VIRGINIA ELECTRIC AND POWER COMPANY
RICHMOND, VIRGINIA 23261

Mr. Harold R. Denton, Director
Office of Nuclear Reactor Regulation
Attn: Mr. O. D. Parr, Chief
Light Water Reactors Branch No. 3
Division of Project Management
U. S. Nuclear Regulatory Commission
Washington, DC 20555

FUEL ASSEMBLY GUIDE TUBE THIMBLE WEAR
Non Proprietary Version

FIGURE 2 FORCES EXERTED ON THE ABSORBER RODLET

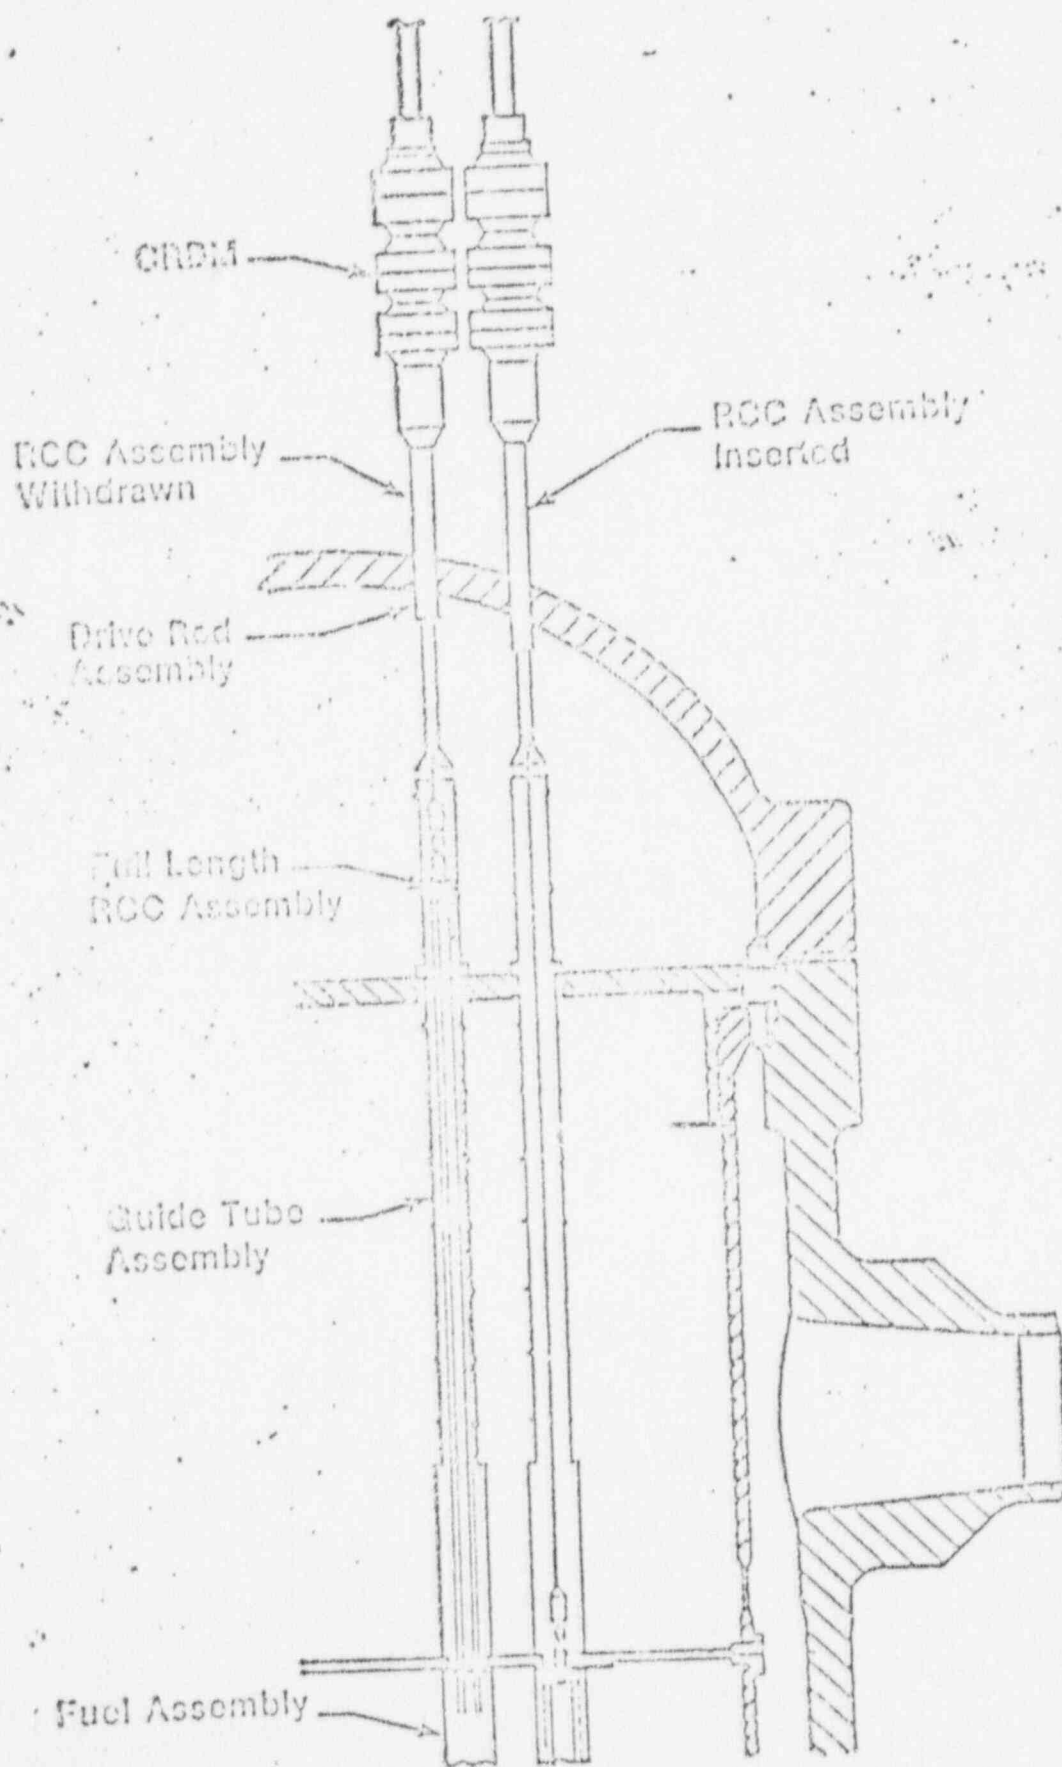
Please provide the basis and derivation of the guide thimble wear model described in Reference 1. In particular, explain assumption 4 and the equations provided under assumption 7. Does the model predict maximum local wear or average circumferential wear?

The rodlet is clamped against the guide tube by the coolant pressure, as illustrated in Figure 2. The length of the clamped portion depends on the coolant pressure Δp and the alignment of the guide tube with the fuel assembly. The rodlet bottom tip is pinned in the fuel assembly guide thimble tube.

As illustrated in Figure 2, a certain portion of the absorber rodlet, with a length "L", is unsupported. As shown in Figure 3, [] The corresponding vibration of the cylindrical rodlet results in the oscillation of the pinned rodlet tip, with a maximum angle of rotation θ . The amplitude of wear motion is a function of this angle, as shown in Figure 4.
